From: Tracey Carroll
Sent: Tuesday, December 11, 2012 9:58 AM
To: Heckman, Lee
Subject: CD-2012-0021 aka 211 S. Lamar Blvd.

RE: 211 S. Lamar Blvd. Planned Unit Development Assessment;
Item 91 on Austin City Council's Agenda for December 13, 2012

211 South Lamar / C814-2012-0160 / Response to Update #1

ENV. TREE
PUD EXHIBIT

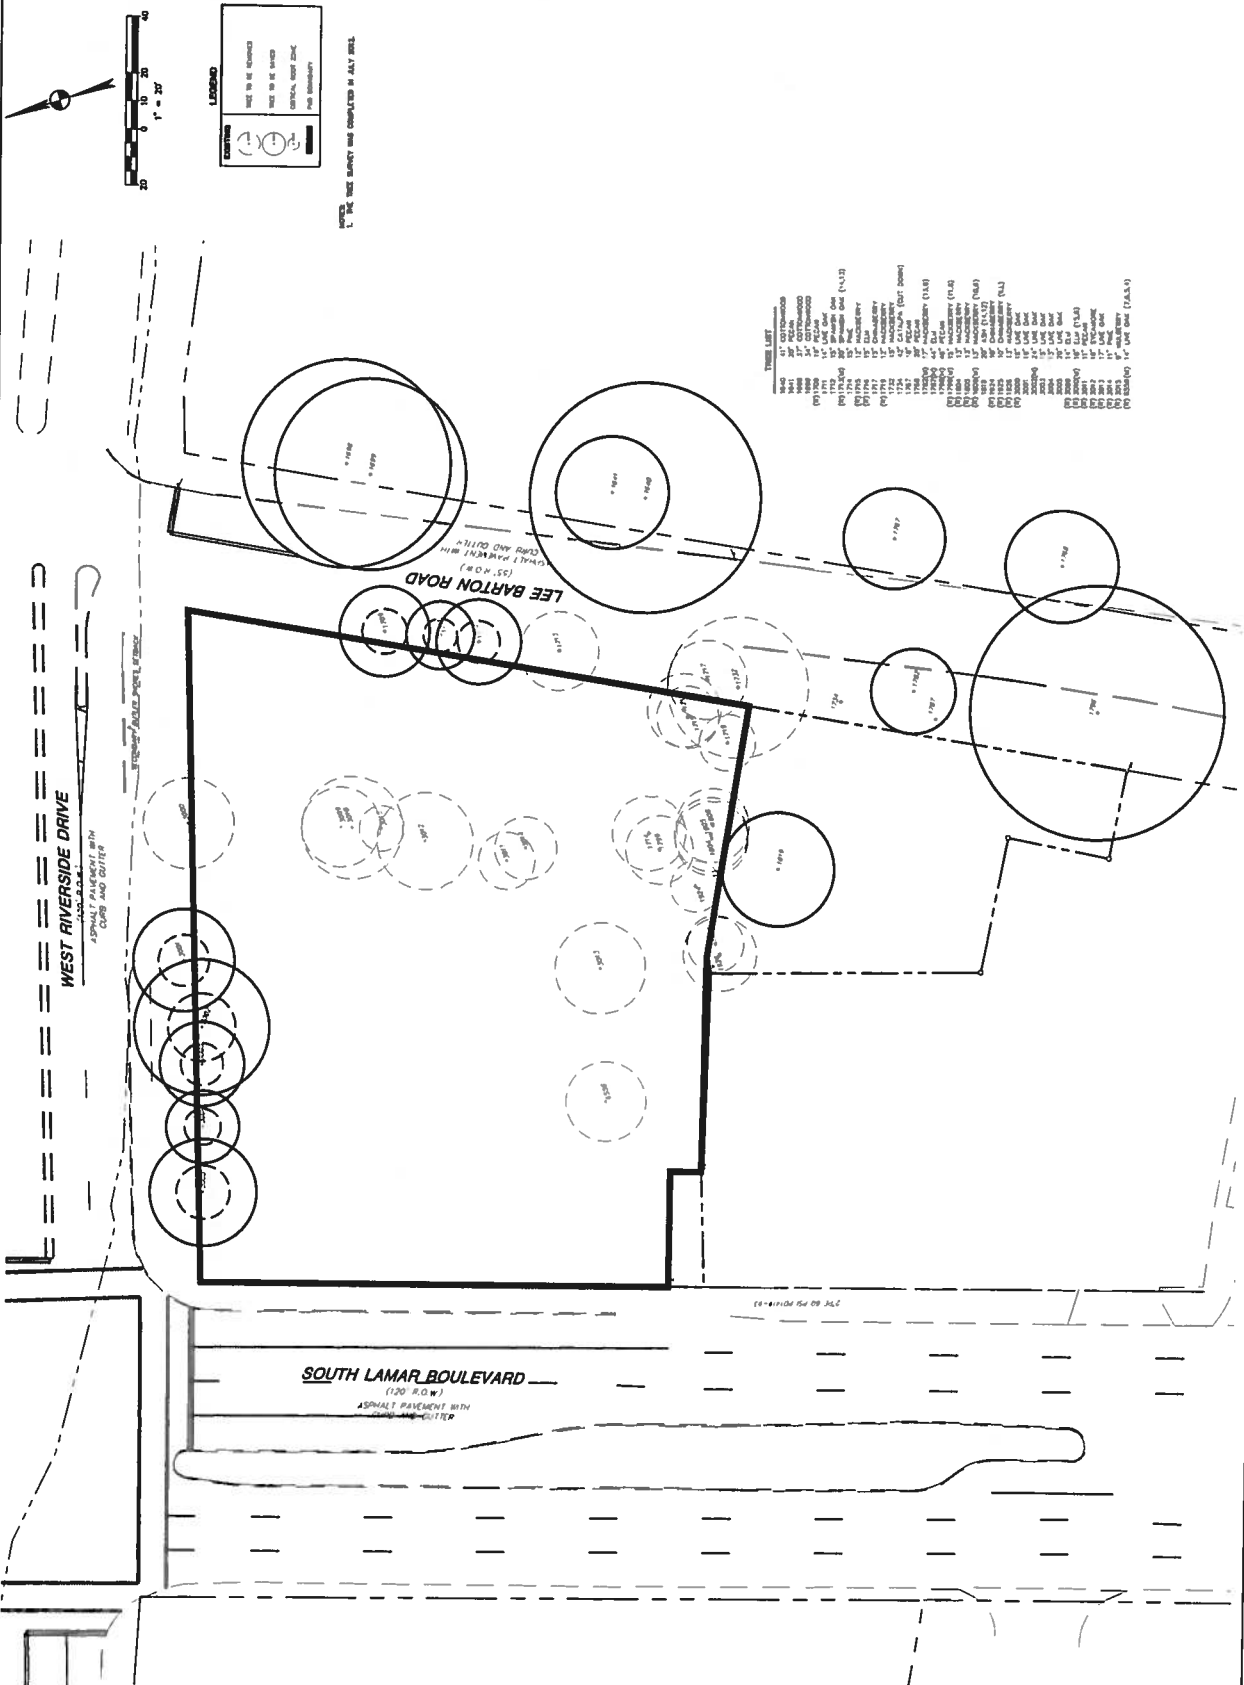
UPDATE #1 Note # 32 addresses the tree preservation criteria required to preserve trees in the PUD. The Env. Tree PUD Exhibit, sheet 4, shows tree #1709 to be removed in the list when it is supposed to remain, and it shows tree 1732 with a 50 ft CRZ instead of a 30 ft CRZ as stated in the tree survey list. Please correct these inconsistencies. This comment can be cleared informally.
